ADA TOWNSHIP SPECIAL PLANNING COMMISSION MEETING

1. Preliminary PUD Plan for 16 Single-Family Home Sites on 4 Acre Site; Request for Rezoning from R-3 Zoning District to R-3/PUD Zoning District, 7699 Fase Street SE, Parcel No. 41-15- 34-402-008, Chuck Hoyt, on behalf of TPR 7699 Fase Street LLC

TO: Ada Township Planning Commission
FROM: Jim Ferro, Planning Director
RE: **Preliminary PUD Plan, 16 Single-Family Residential Home Sites on 4 Acres, Rezoning R-3 District to R-3/PUD District, 7699 Fase St., Parcel No. 41-15-34-402-008, TPR 7699 Fase Street, LLC**

7699 FASE ST. PUD

Site Layout Plan
7699 Fase Street SE Ada, MI 49301

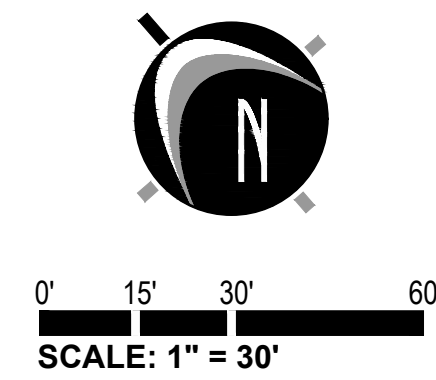
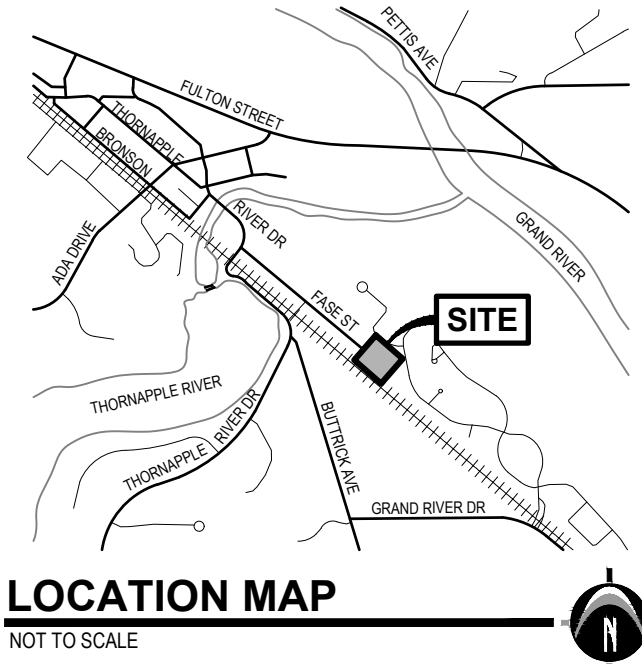
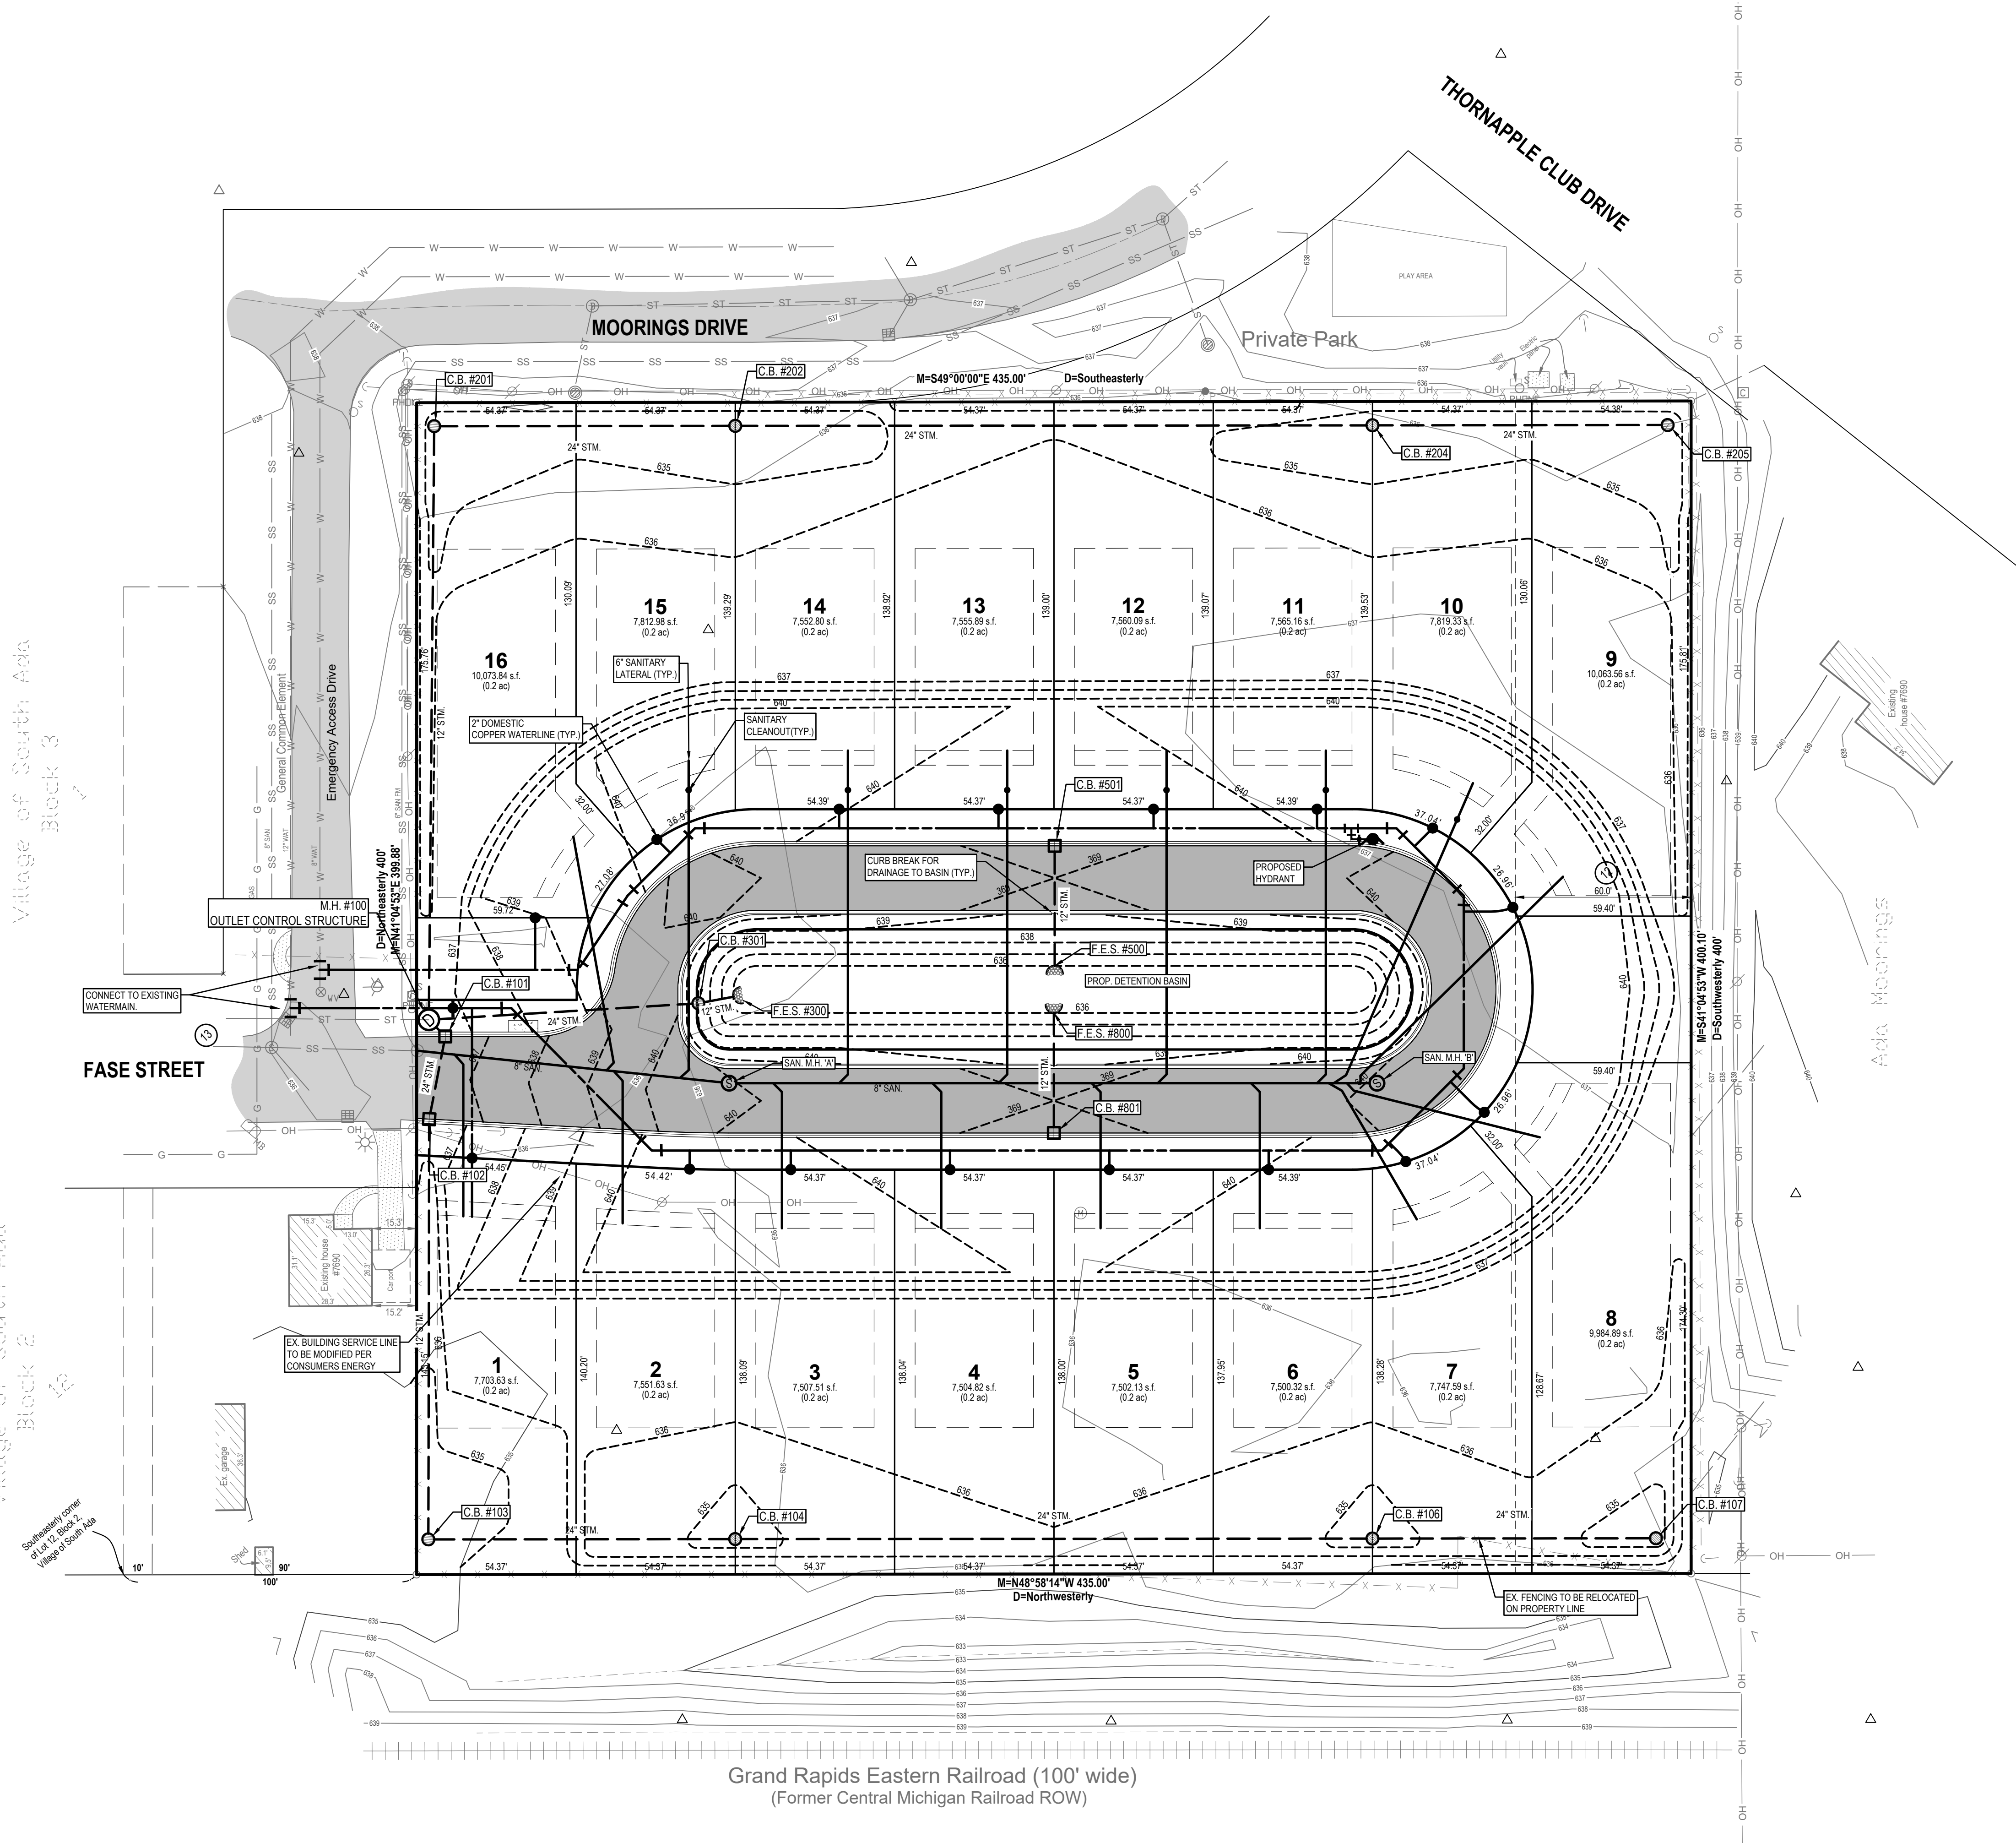
It is recommended that the Preliminary PUD Plan be revised to provide a 5 foot-wide sidewalk at the inside edge of the road right-of-way through the development. The expected traffic generation from the development is well within the existing street system capacity.

5. The Preliminary PUD Plan shall be modified to expand the open space area at the east end of the site, revise the boundary of Unit 9 to reduce its square footage and minimum front setback line to be aligned east-to-west with the front setback lines on Units 10-15.

The applicant has submitted a revised utility layout plan that removes the originally-proposed extension of a water main onto Ada Moorings property. The revised layout completes a looped main through the development within the road right-of way, connecting to existing water mains in Fase St.
